UNITED STATES  
DEPARTMENT OF THE INTERIOR  
NATIONAL PARK SERVICE  
COOPERATING WITH  
MICHIGAN  
DEPARTMENT OF CONSERVATION

DRAWN BY: R.M.K.  
DESIGNED BY: C.M.L.-H.J.N.-G.P.  
CHECKED BY: C.M.L.  
J.W. WELLS STATE PARK SP9  
PARKING AREA NO. 1  
DATE: 5-13-37

# TYPICAL CROSS-SECTION

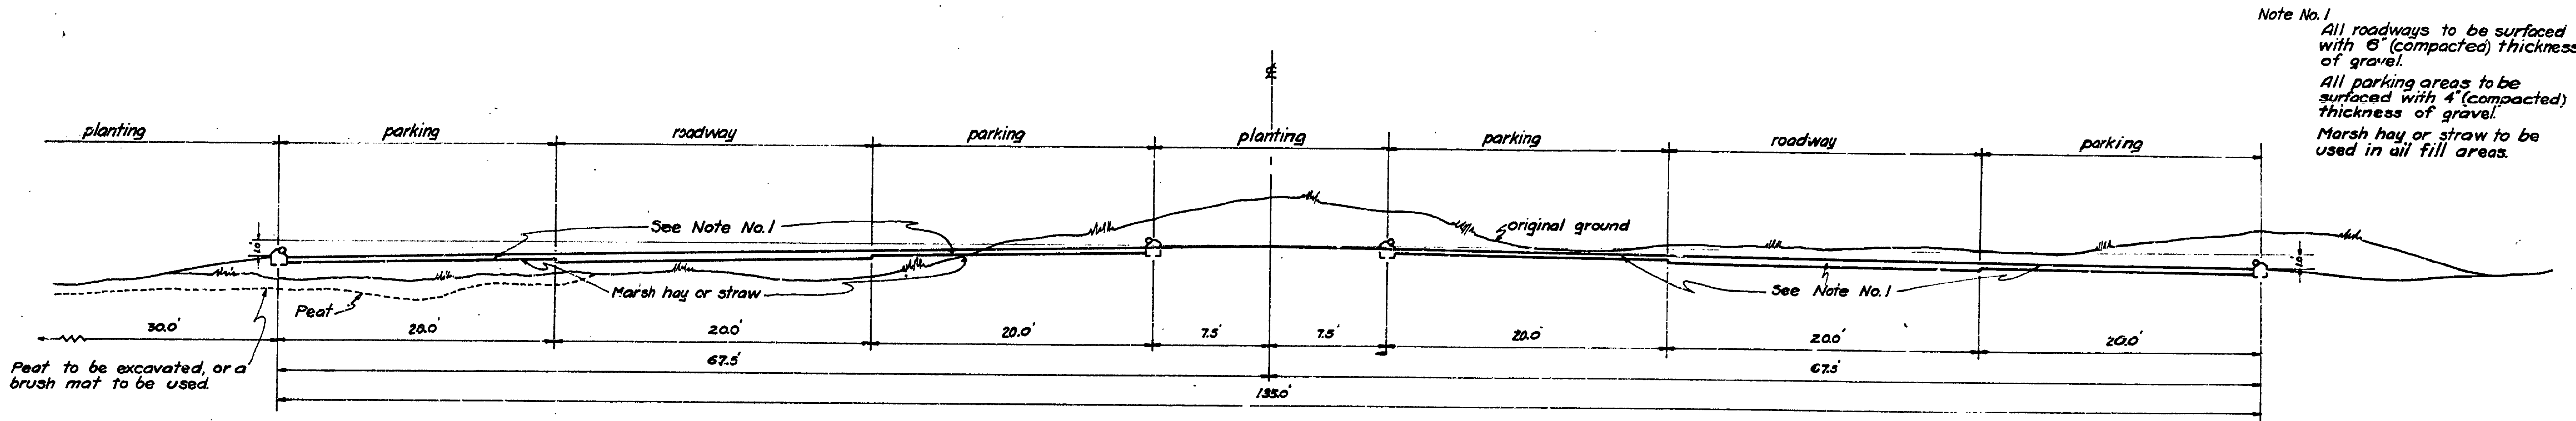
REVISIONS  
MAY 27, 1937  
SECOND REGIONAL OFFICE  
PARKING AREAS CHANGED FROM 15' TO 20' DEEP.  
DIMENSIONS CORRECTED ON TYPICAL CROSS SEC.
